**Re: Seacoast Reliability Project - SEC Docket 2015-04
Wetlands Permit Amendment Request
Minor Construction-Related Change
Submarine Cable Re-alignment**

Public Service Company of New Hampshire d/b/a Eversource Energy (“Eversource”) hereby submits to the New Hampshire Department of Environmental Services (“Department” or “NHDES”) a request for a minor modification to the Department’s October 29, 2018 Revised Final Decision, which authorized Eversource to construct portions of the Seacoast Reliability Project (“SRP” or “Project”) in Little Bay. Eversource and its submarine contractors have identified a need to make a micro adjustment to the submarine cable alignment within the existing NOAA charted cable area in Little Bay to avoid newly formed and identified obstructions caused by tidal currents. The result of the micro-adjustment will result in an increase length of each of the threes cables in the Bay of eight (8) feet and shift a portion of the cables in the channel a maximum distance of 96-feet from the current alignment. Attached to this request is Eversource’s ***Description and Technical Justification*** for the required minor submarine cable realignment in the channel of

Figure 2: 2019 Bathymetric survey within the charted cable corridor

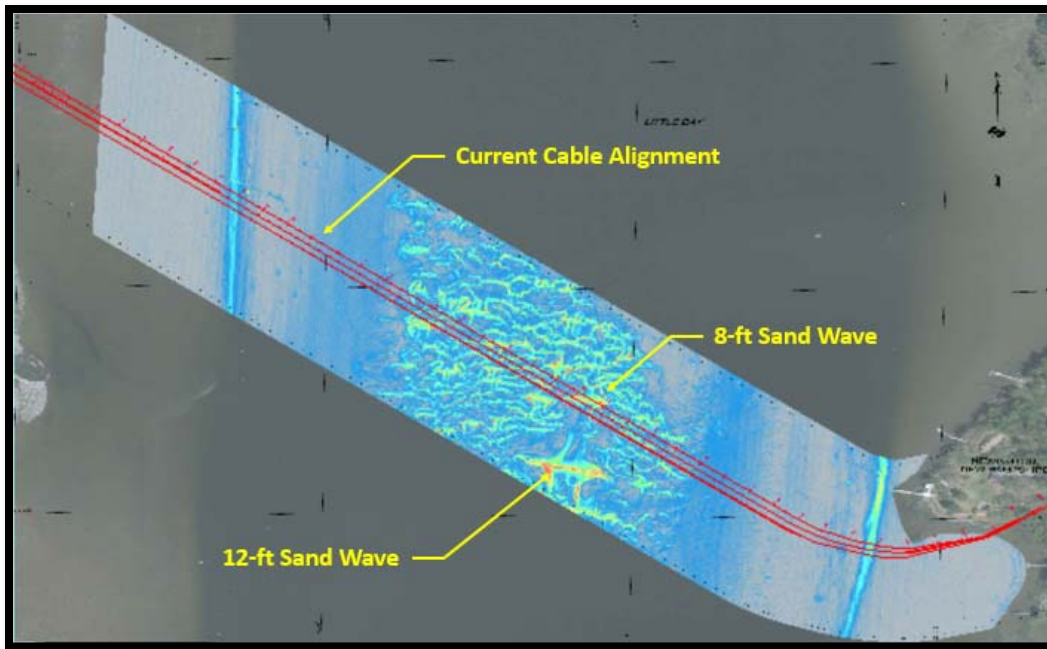
On 28 August 2019, OSI performed a pre-construction bathymetric survey along the permitted cable alignments. A 230-meter corridor centered on the original cable alignment was surveyed using a multibeam echosounder. During this survey, sand waves were observed as large as 12-ft, and an 8-ft high sand wave was observed on the cable route as shown on Figure 2. Side slopes on the sand wave were estimated to be at least 30°. Subsequent bathymetric surveys were performed on September 15, 16 and 17, 2019. All subsequent surveys showed that the sand waves had not changed substantially in size or position.

Figure 3: Cable realignment within the charted cable corridor

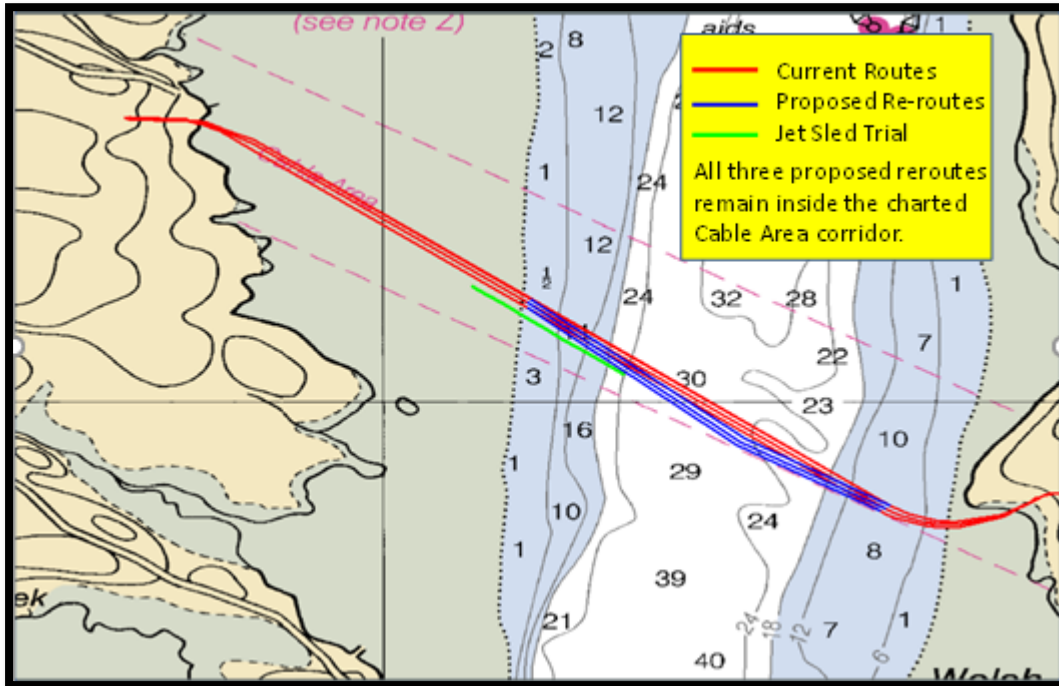
A proposed reroute of all three cables is shown on the *Amended Engineering Drawings* provided in Appendix A and *Amended Environmental Maps* (Sheets 20 through 22) in Appendix B. The realignment consists of an approximately 4° shift southward from the existing alignment of the three conductors starting in the western

mudflats to a maximum horizontal distance southward of approximately 96 ft in the channel of Little Bay. The alignment then shifts northward approximately 6° meeting with the existing alignment in the eastern mudflats. The proposed reroutes will add approximately eight (8)-ft of cable to each cable segment. Avoidance of the sand wave will greatly reduce the risk of damage to the jet sled and/or the cable, allow full burial depth and provide better long-term security for the cables. All three proposed cable re-routes have been engineered to maintain positioning of the cables within the charted Cable Area corridor as shown in Figure 3 below.

To allow for preferential jet plow navigation, there may be minor variations in the horizontal as-laid cable path on the order of approximately ±10-ft. These slight variations are routine in the industry, and may be necessary to adjust the jet plow towing angle to maintain heading or pulling the cable inside the angle of an alter course. Alignment variations are achieved through adjustment of cable tension and do not require anchor changes.

Figure 5A: Cable realignment vibracore sample locations 2019

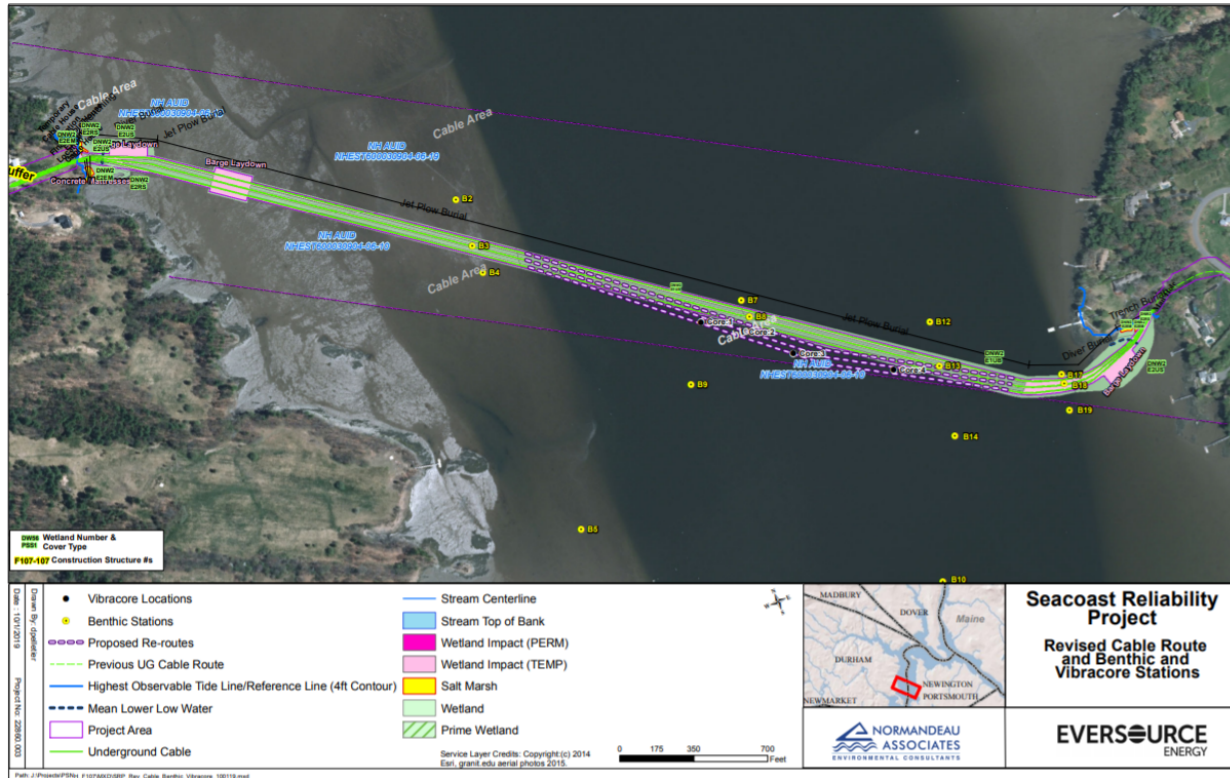
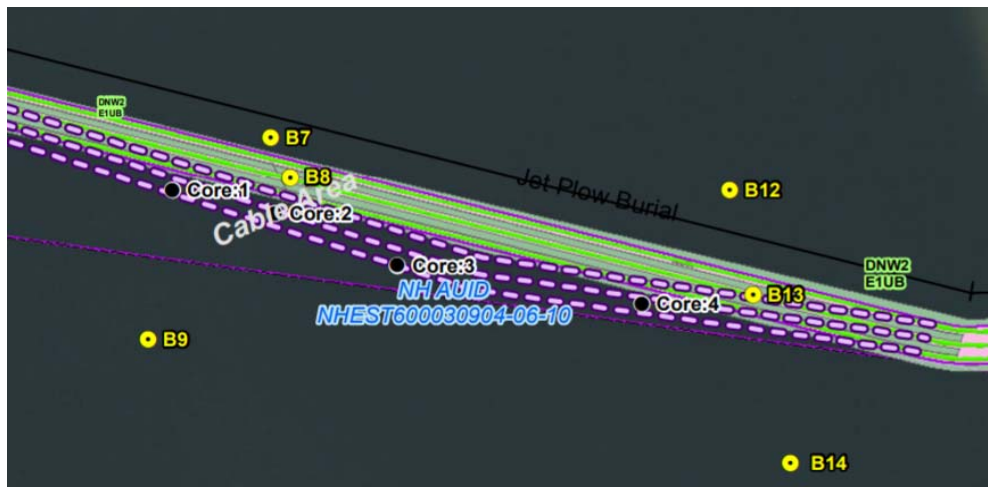
As conservative measure, sediment sampling was conducted along the route realignment to confirm consistency with previous assessment data. On September 24, 2019 Normandeau conducted vibracore sampling at four (4) locations (COR-1 through COR-4) along the cable realignment route in the Channel of Little Bay as shown on Figure 5A and 5B.

PROFILE VIEW

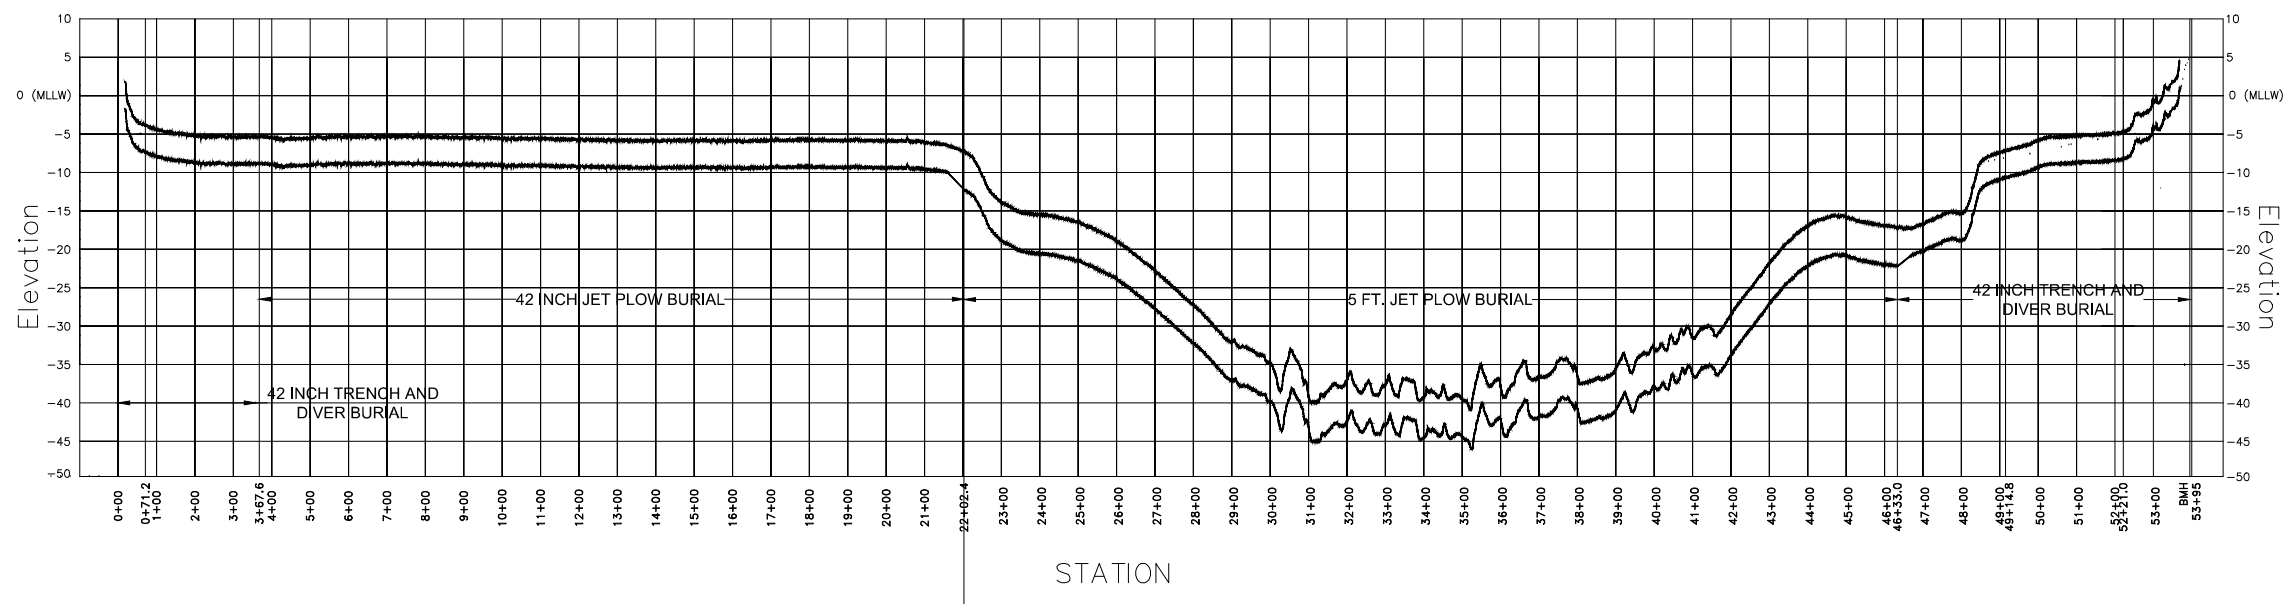
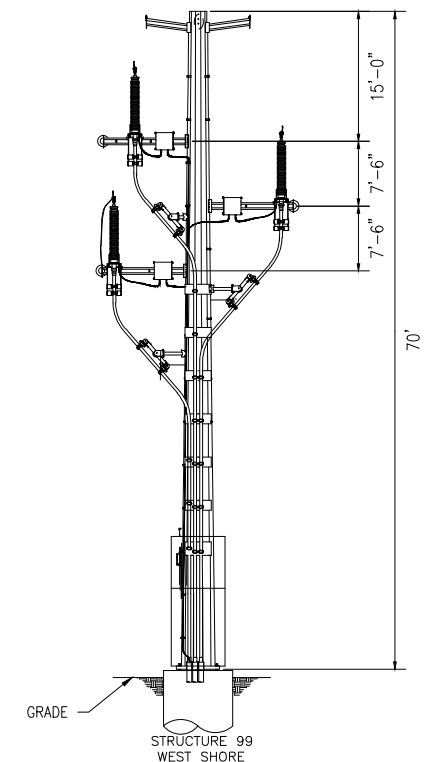
NO.	REVISION	DATE	DRWN	CHKD	APPR
11	Revised: Jet Plow Alignment for Sand Wave	9/19	-	-	-
10	Revised: Jet Plow Target Depth	8/17	-	-	-

Figure 6 Illustration of adjusted route relative to the modeled route (Source: Normandeau).

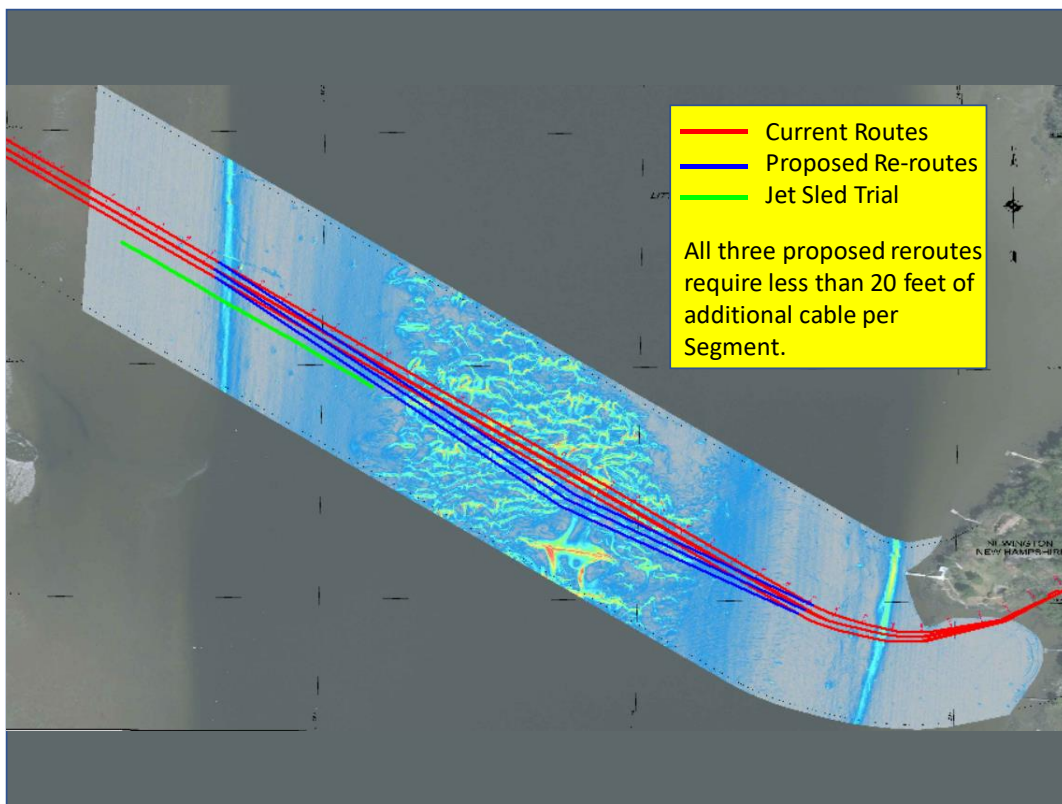
The cable burial route is proposed to be slightly adjusted to avoid a sand wave area where steeper bottom slopes exist. The adjustment is an offset from the original route for a short distance with a maximum offset of ~100 ft (~33 m) (see Figure 6).

The slight route offset will not affect the modeling results due to the small distance change from the original route. The resolution of the sediment transport modeling grid (where the excess sediment concentration and deposition is calculated) is 20 m (66 ft) in the plan view and 0.2 m (8 in) in the vertical. Thus the adjusted route would result in the sediment source (the jet plow) being located only 1-2 grid cells from the original modeled location. Although there will be a shift in the location of the maximum concentrations (>> 20 mg/L) right at and locally surrounding the jet plow, this is not anticipated to have an effect on the modeling results at large, particularly at distances where the 20 mg/L mixing zone area is delineated.

Further it is suggested that the route adjustment will not significantly change the model predictions, and therefore the previously completed modeling is deemed a useful proxy for the adjusted route.
